ITEM: 6.12	COMMITTEE OF ADJUSTMENT REPORT SUMMARY MINOR VARIANCE APPLICATION FILE NUMBER A145/23 435 CITYVIEW BLVD, WOODBRIDGE
-------------------	--

**COMMITTEE OF ADJUSTMENT REPORT
MINOR VARIANCE APPLICATION
A145/23
435 CITYVIEW BLVD, WOODBRIDGE**

ITEM NUMBER: 6.12	CITY WARD #: 3
APPLICANT:	435 Cityview Inc.
AGENT:	Brutto Consulting
PROPERTY:	435 Cityview Blvd, Woodbridge
ZONING DESIGNATION:	See Below
VAUGHAN OFFICIAL PLAN (2010) DESIGNATION:	Vaughan Official Plan 2010 ('VOP 2010'): "Prestige Employment"
RELATED DEVELOPMENT APPLICATIONS:	DA.22.078
PURPOSE OF APPLICATION:	Relief from the Zoning By-law is being requested to permit the development of a two-storey industrial/office building and to facilitate related Site Plan Application DA.22.078.

CELITE CONSTRUCTION

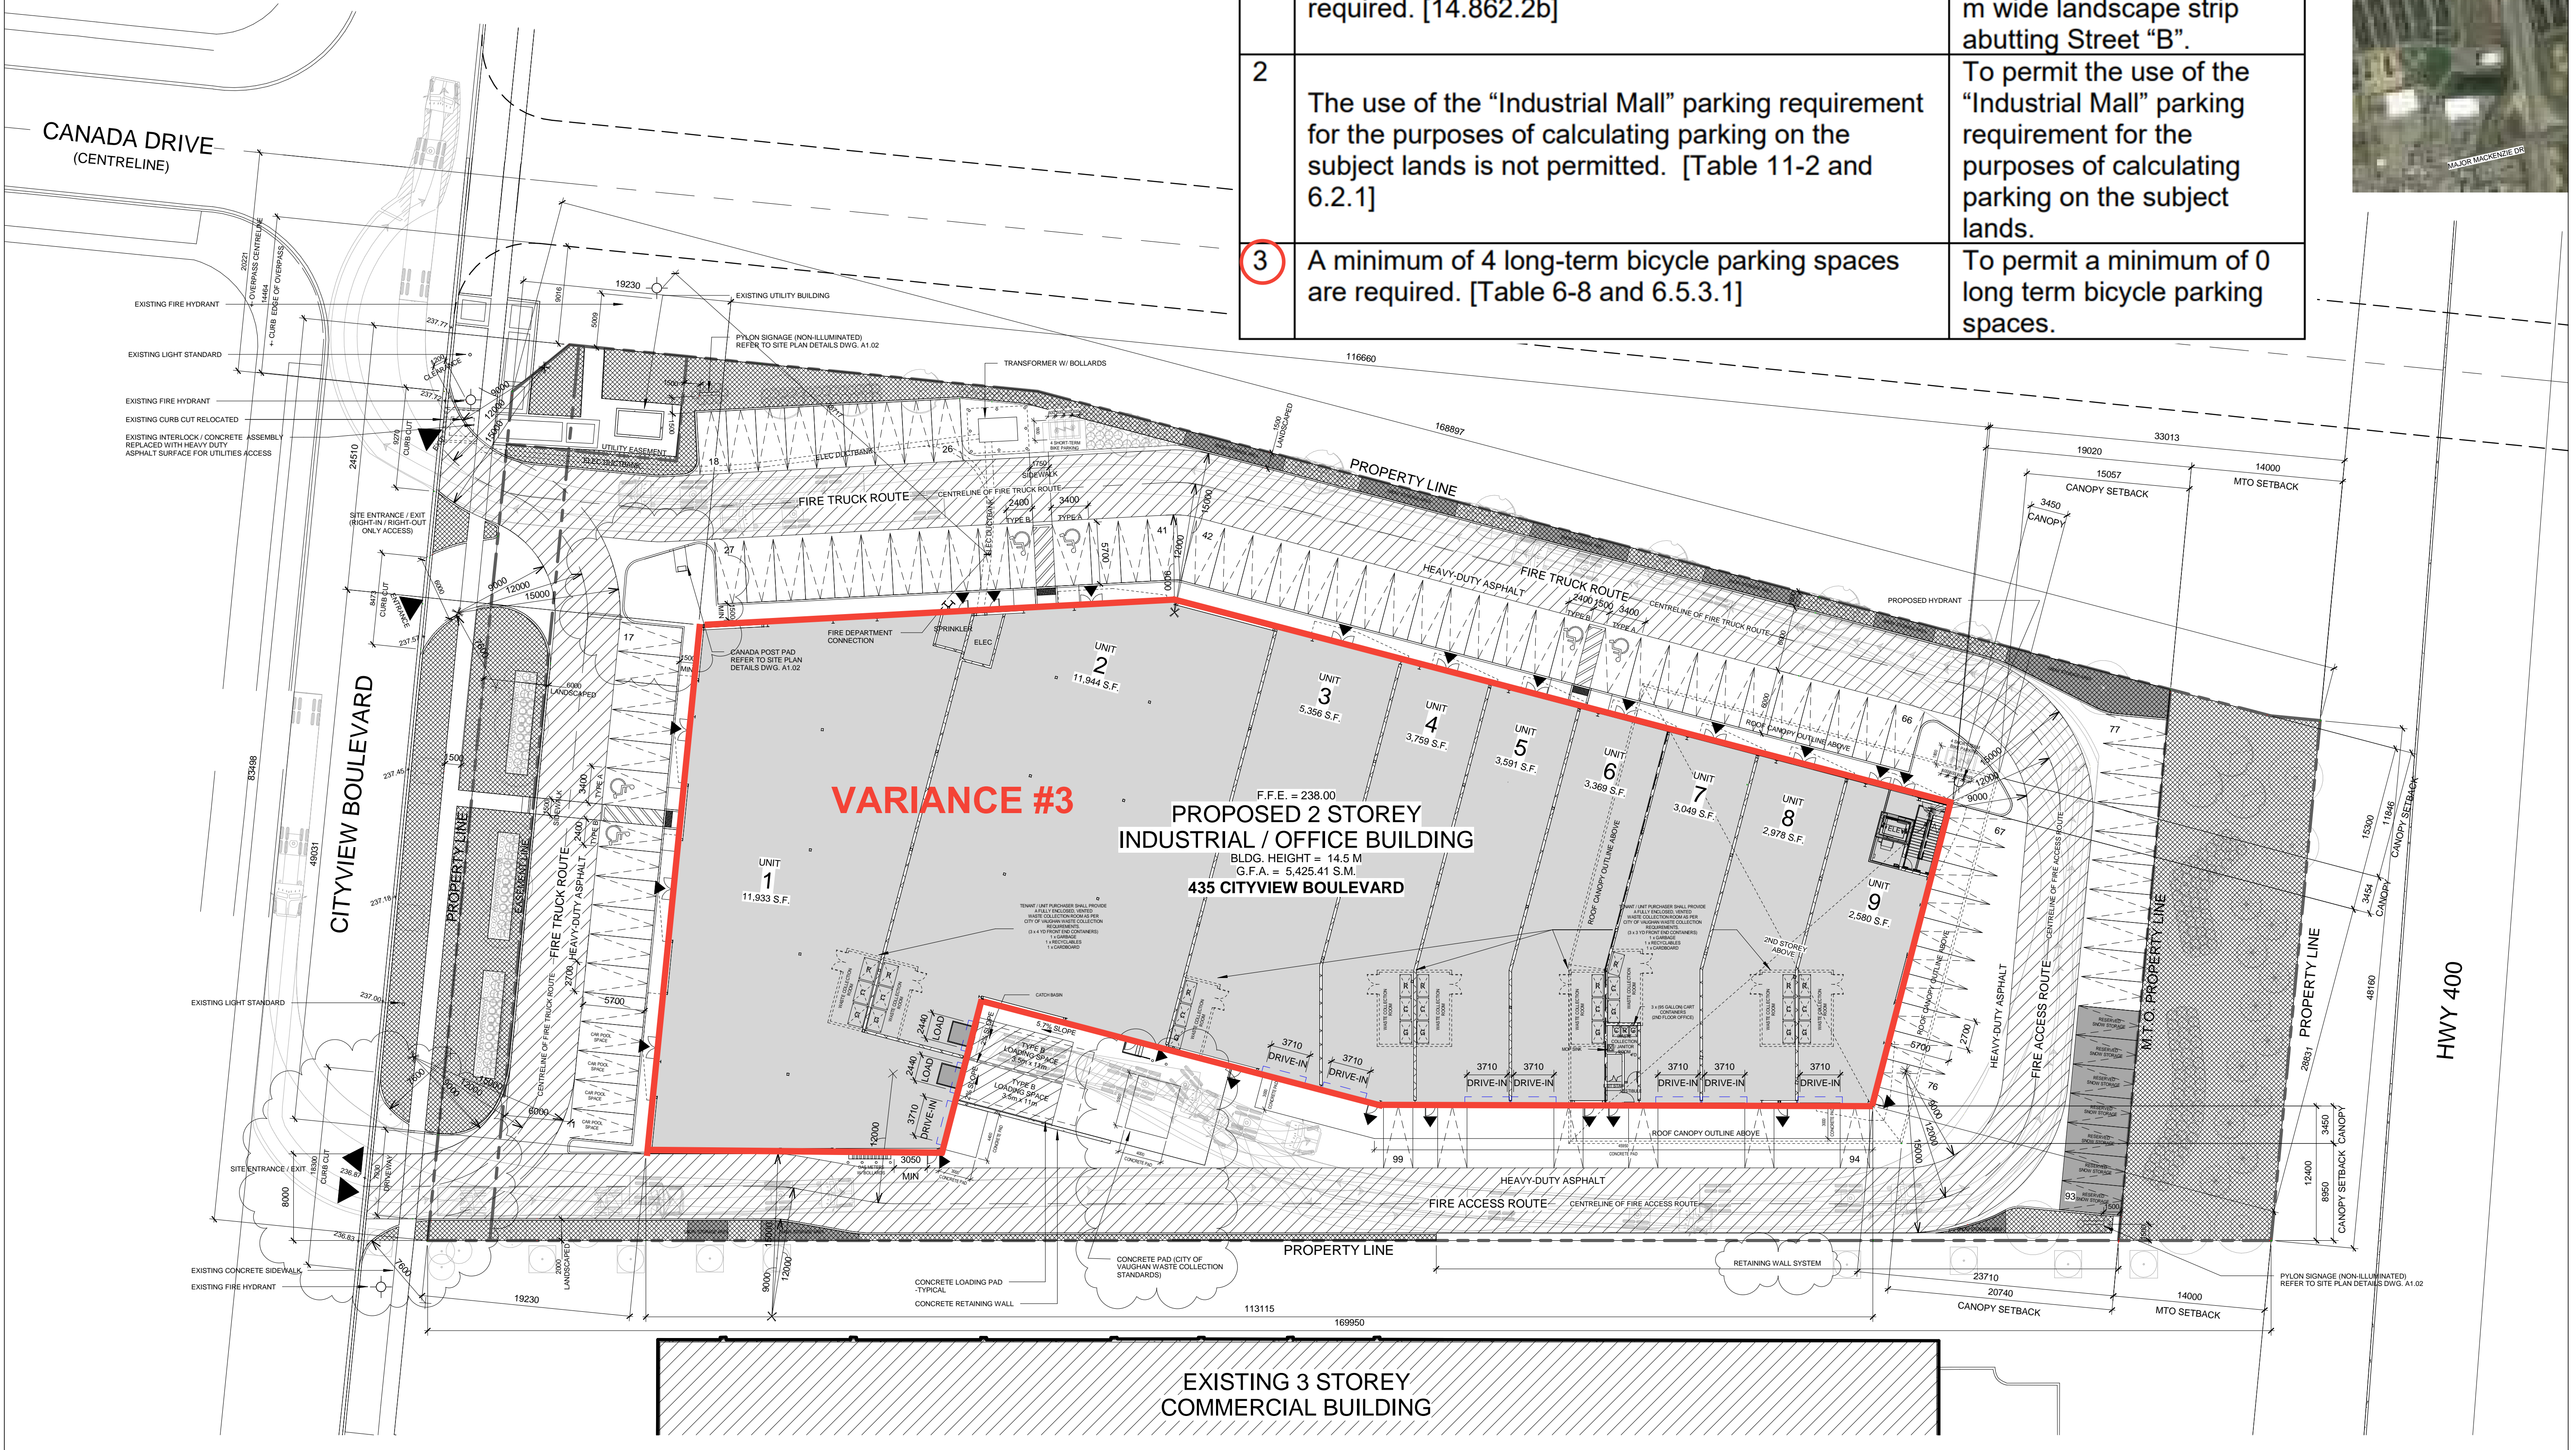
The Development Planning Department has no objection to Variance 1 to permit the proposed 1.5 m landscape strip abutting Street “B”. This requested variance was reviewed by Urban Design Staff through the supporting Site Development Application (File DA.22.078), who had no concerns with the proposed landscape strip width.

The Development Planning Department has no objection to Variance 2 to permit the use of the “Industrial Mall” parking requirement for the purposes of calculating parking on the subject lands. The proposed Standard Condominium tenure will allow industrial and commercial tenants to lease the units individually, similar to a shopping mall. Parking requirements for the individual units cannot be determined at this time, as the tenancy for the building has not yet been established. Applying the ‘Industrial Mall’ parking requirements to the subject lands allows for the application of a site-wide calculation as opposed to calculating the number of spaces required for the use in each unit. The subject lands are zoned “EM1 - Prestige Employment Zone” by Zoning By-law 001-2021 which does not permit an ‘Industrial Mall’. A recommendation from staff to permit the ‘Industrial Mall’ use within the EM1 Zone was adopted by Council on May 17, 2022, and is anticipated to go to a future Council Meeting for implementation as part of a general amendment. The proposed parking ratio will comply with Zoning By-law 001-2021 once the ‘Industrial Mall’ use is added to the EM1 Zone.

The Development Planning Department has no objection to Variance 3 to permit a minimum of 0 long-term bicycle parking spaces. The four (4) required long-term bicycle parking spaces will be provided but are to be accessed differently from what the by-law requires. The by-law requires the spaces to be located in a common area. The four largest units are proposed to have 1 space each. Therefore, the intent of the by-law to provide long term parking spaces at the correct number is being maintained. A condition is requested to ensure the parking is provided in light of the relief being sought.

1. That all comments including the provision of 4 long term bicycle parking spaces on Site Development Application DA.22.078, be addressed to the satisfaction of the Development Planning Department.
